Project	<b>IEEE 802.16 Broadband Wireless Access Working Group</b> < <a href="http://ieee802.org/16">http://ieee802.org/16</a> >	
Title	Corrections for downlink STC in OFDMA PHY	
Date Submitted	<b>2005-01-24</b>	
Source(s)	Yuval Lomnitz Yigal Eliaspur Intel.	<a href="mailto:Yuval.Lomnitz@intel.com">Yuval.Lomnitz@intel.com</a> <a href="mailto:Yigal.Eliaspur@intel.com">Yigal.Eliaspur@intel.com</a>
	Yigal Leiba Yossi Segal Runcom Ltd.	<a href="mailto:yigall@runcom.co.il">yigall@runcom.co.il</a> <a href="mailto:yosis@runcom.co.il">yosis@runcom.co.il</a>
Re:	IEEE P802.16REVd/D5-2004	
Abstract	Corrections and clarifications of definitions for STC in OFDMA PHY.	
Purpose	Adopt changes.	
Notice	This document has been prepared to assist IEEE 802.16. It is offered as a basis for discussion and is not binding on the contributing individual(s) or organization(s). The material in this document is subject to change in form and content after further study. The contributor(s) reserve(s) the right to add, amend or withdraw material contained herein.

# Corrections for downlink STC in OFDMA PHY

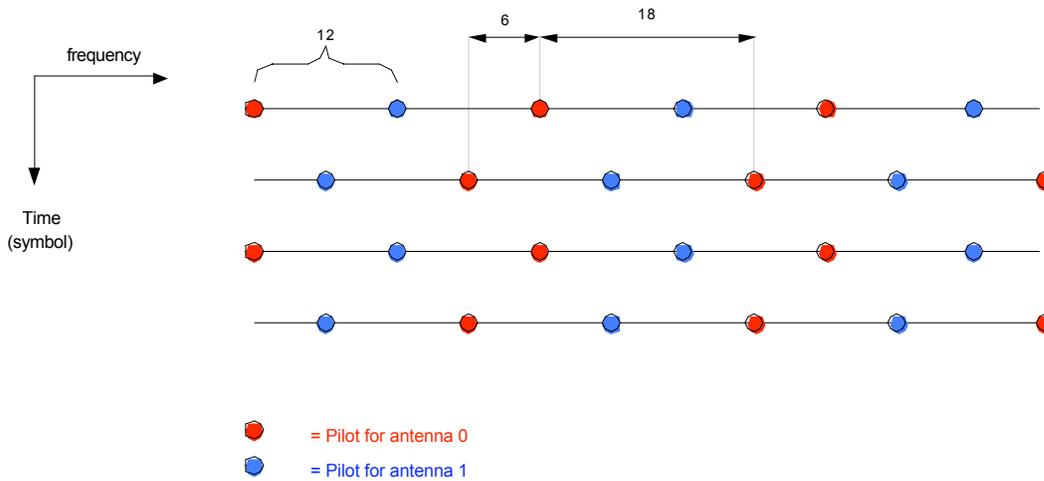
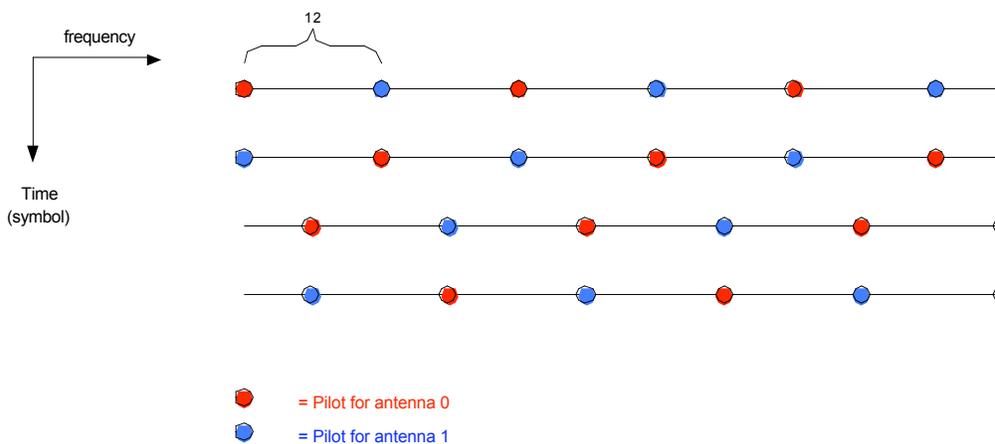
Equation (106) in section 8.4.6.1.2.2 (Symbol Structure for FUSC) defines that FUSC variable pilots are shifted by 6 in each odd symbol. However in STC this creates a problem:

1. Shifting the pilots changes the location of data subcarriers, resulting in the fact that the STC doesn't operate on QAM symbols transmitted in the same frequency. This makes STC combining complex and suboptimal.
2. The operation of STC coding is defined as exchanging tones with the same index for two OFDMA symbols. The STC operation is not well defined when data tones change their locations.
3. The movement of the pilots creates an irregular pilot pattern that doesn't improve channel estimation, as depicted below. It seems that the original intention was merely to exchange pilot-sets between the antennas.

On the other hand, canceling the movement of the pilot will result in regular structure, but will degrade the channel estimation performance (12 tone separation @11Khz carrier spacing = limited to 7us delay spread).

So our proposal is to define that pilot movement is every 2<sup>nd</sup> symbol.

The maximum pilot spacing over 2 OFDMA symbols is 18 tones (and the minimum is 6 tones)

The pilot spacing (from one antenna) in two OFDMA symbols is 12 tones.
